E3910A/B-02-S

S E R V I C E N O T E

HP E3910A/B PT500 Protocol Tester

High voltage applied to the connector module plane or connector module handle could cause the existing ground path to open, resulting in a possible shock hazard to the user.

PT BACK BEZEL GROUNDING WIRES UPGRADE

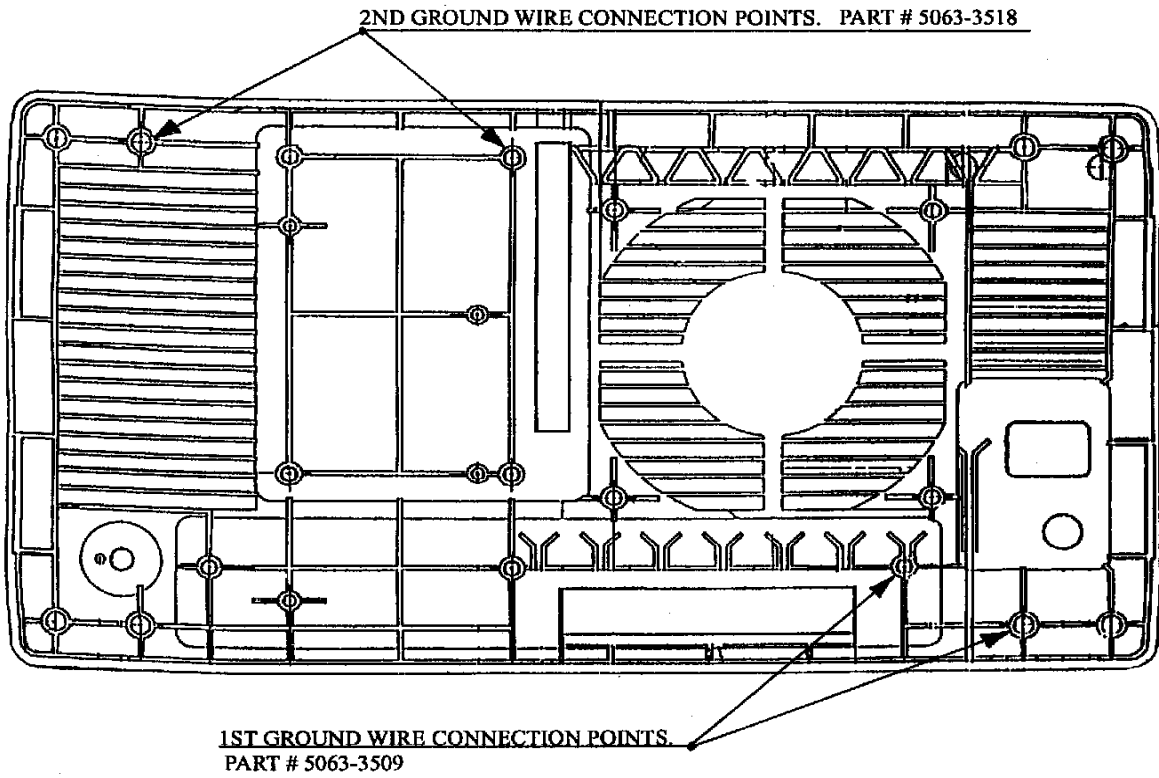
A situation exists in which a unit in the referenced serial number range could possibly become a shock hazard to personnel. This situation would likely only occur if high voltage is present on the connector module plane or connector module handle and the existing ground path was blown away. The existing ground path is insufficient to carry current specified by Hewlett-Packard safety requirements. This situation has occurred to date only when checking the unit with a megger or similar device.

Affected units must be retrofitted with grounding wires to rectify the problem, using the following instructions.

- Remove top cover of instrument and interface module.
- Install longer (11 cm) ground cable, p/n 5063-3518, to existing screw of upper left hand side member bracket hole.
- Connect to inside connector module hole, beside degaussing board, with 4x5 screw.

- Remove bottom cover of instrument and auxilliary connector module.
- Install 8 cm ground cable, p/n 5063-3509, to right hand side hole of auxilliary connector with 4x5 screw.

- Connector module handle should be grounded from the rear handle screw to the nearest DB style connector screw by installing one of the 5063-3510 wires between these two points.
- Use the four 4x28 screws to reinstall connector module.

- Applies only to MPT368.2, IPT468, XPE systems with no parallel printer connector, that is, with auxilliary connector module 4010-0070-IDA.
- Install grounding wire between the handle mounting screw and the nearest screw of the "PRINTER" connector.
- Reinstall auxilliary connector module using three 4x25 screws.
